APP. EXHIBIT# 1
CASE: 2024-0215-V
DATE: 4/29/25

Fwd: 779 Snodgrass County comments

RE: Perc #T02044175
Tax Account #241303171620
Site: SNODGRASS ROAD
CROWNSVILLE

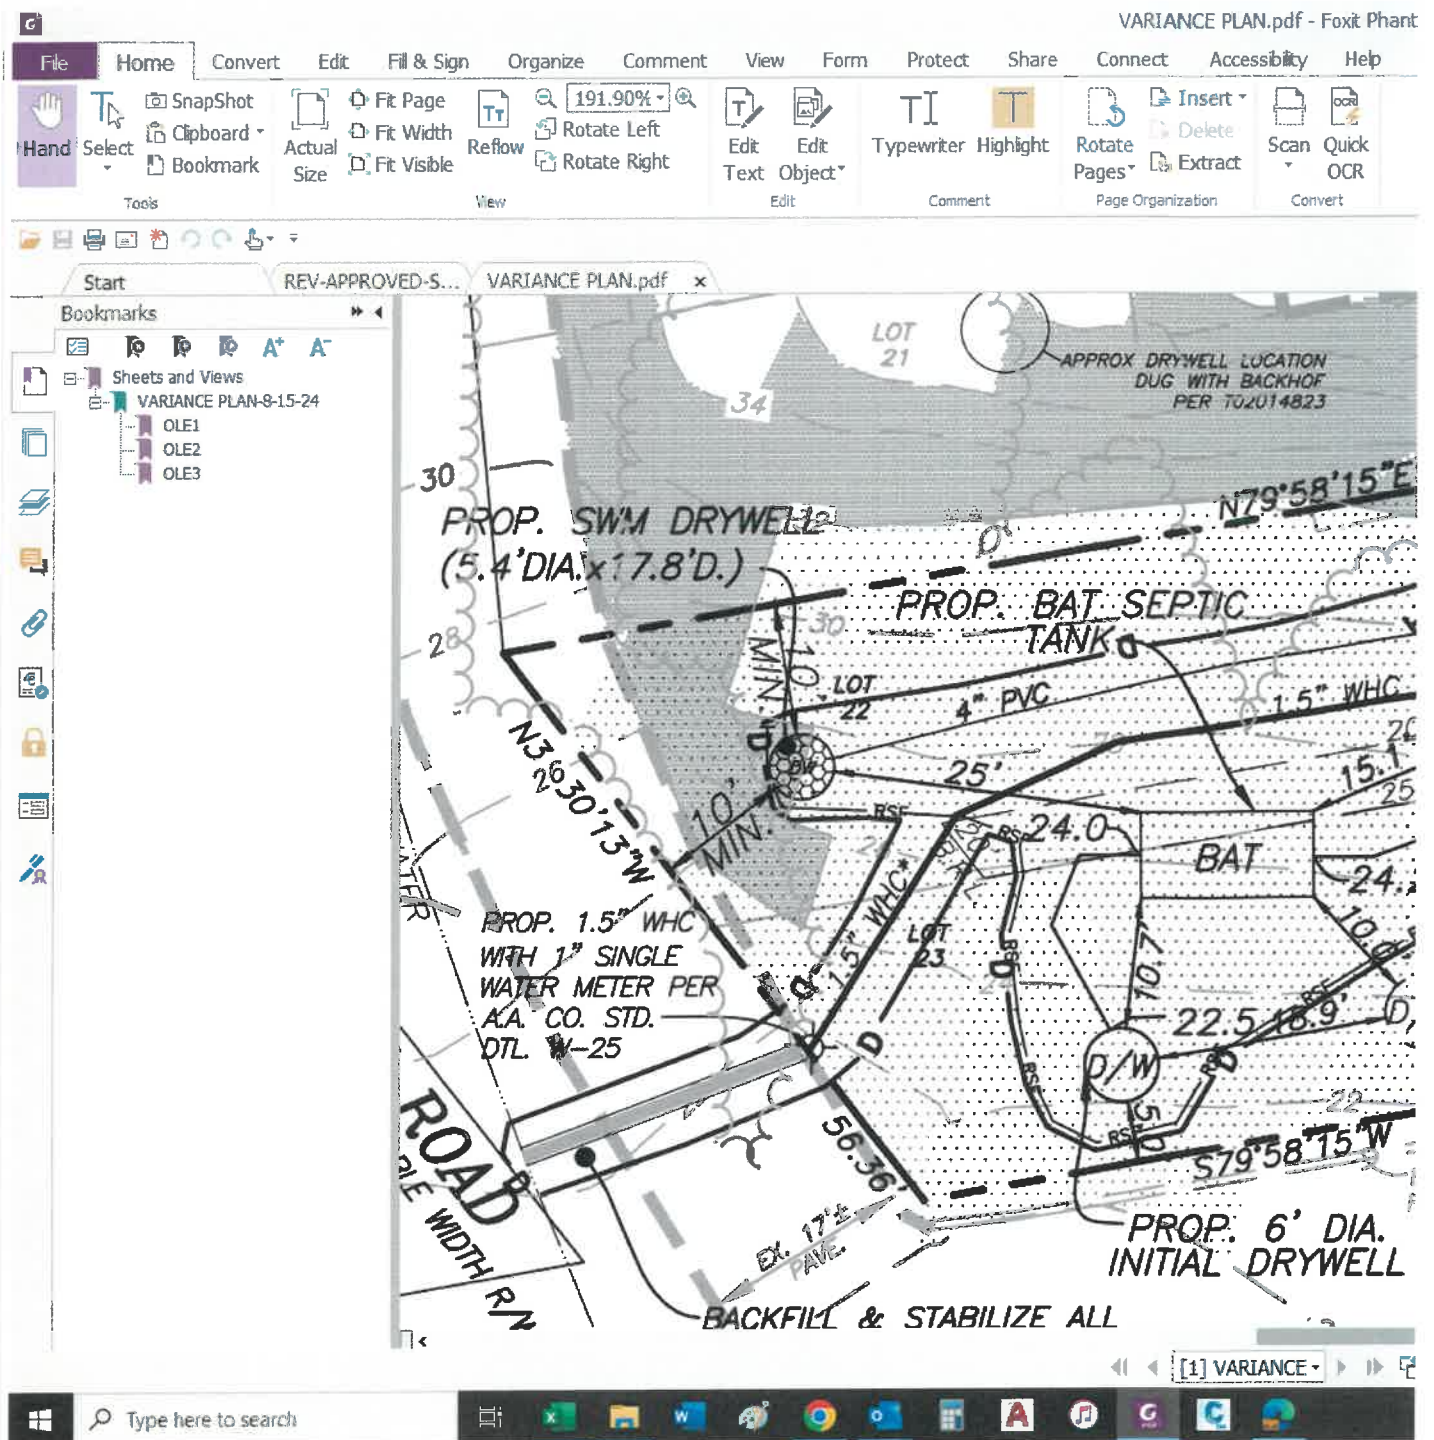
On Tue, Apr 22, 2025 at 8:49 AM Matthew Rhoderick <mdrhoder@gmail.com> wrote:
Hi Brian,
My name is Matt Rhoderick and I am reaching out about a comment letter from March 3rd on the subject property for variance #2024-0215-V. I left a message by phone this morning b
Per the email chain below, and total submittal package in the Adobe acrobat link 2 emails down, we believe the site plan matches the latest approved health department plan stamped ;
Could you provide clarification for any items needing additional detail or not matching? The comment received was that the site plans does not match the approved plan. Is it possible tl

Can you advise on the county comment that the site plans do not match the approved health department plan? Im stumped.

I have pulled the files and compared all the plans again. I agree with you, the revised approved septic plan and revised variance plan do match. We must have looked at an old plan duri

Other than I had larry re-label some items on the variance plan differently (diameter for swm drywell, size of water connection, silt fence, sce, freeze perc, etc....) t

I specifically showed the lod (which falls on top of each other) so that the reviewers could see the plans were the same. Do you think they re-printed the earlier let may want to reach out to brian at health dept. for clarification

DEPARTMENT OF HEALTH
PERC APPLICATION

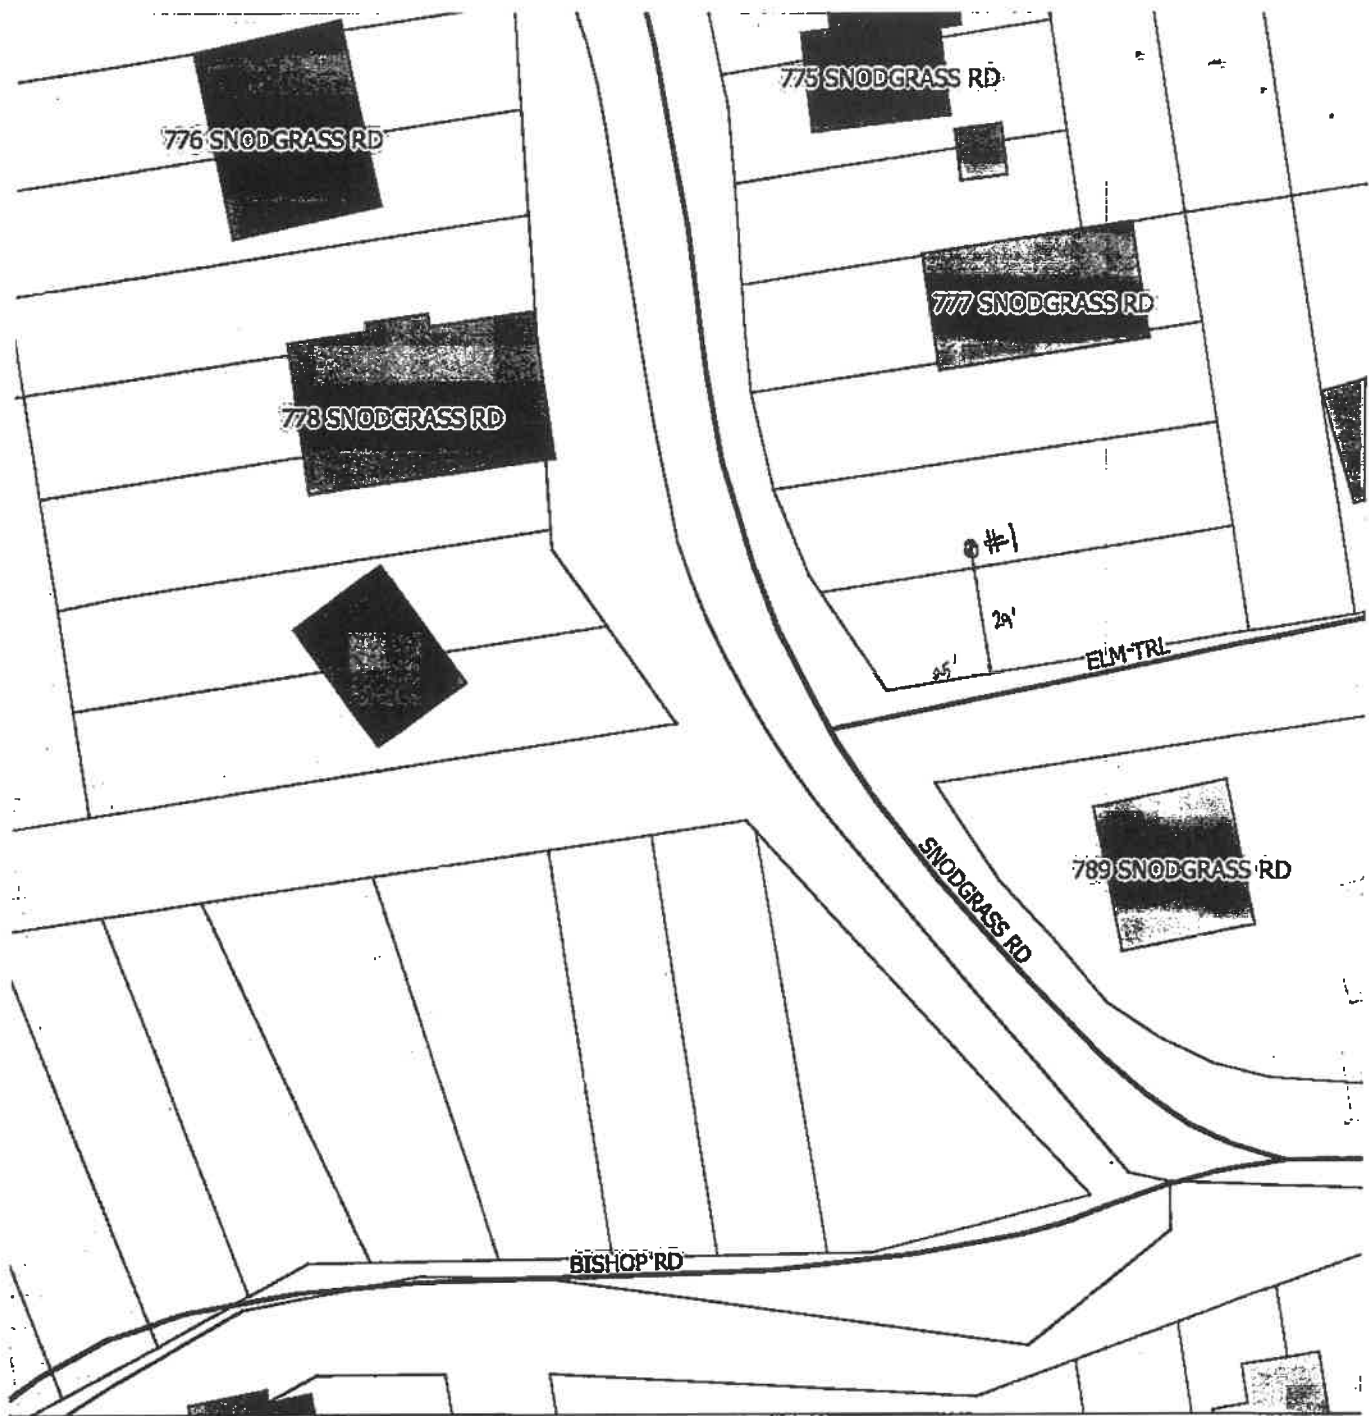
Entire lot approx 15% slope

Other: BAT UNIT REQUIRED. STAY 25' OFF 25% SLOPE. THIS PROPERTY MAY CONTAIN INSUFFICIENT AREA FOR AN INITIAL SYSTEM AND TWO REPLACEMENTS
